Service Information-TB

No.: SI-TB2023071101 Date: 11-07-2023 Version: 1.0

Subject: Software update synchronization

Vehicle Model: MG4(EH32-X1)

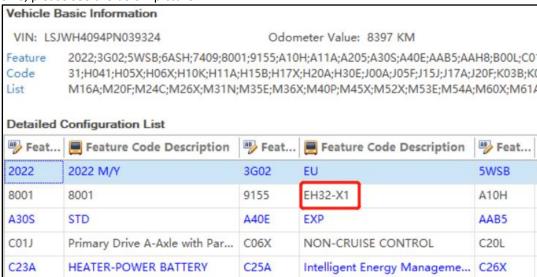
Note: This bulletin is only applicable for EH32-X1, which can be identified by the vehicle information in SIPS, please see the below picture.
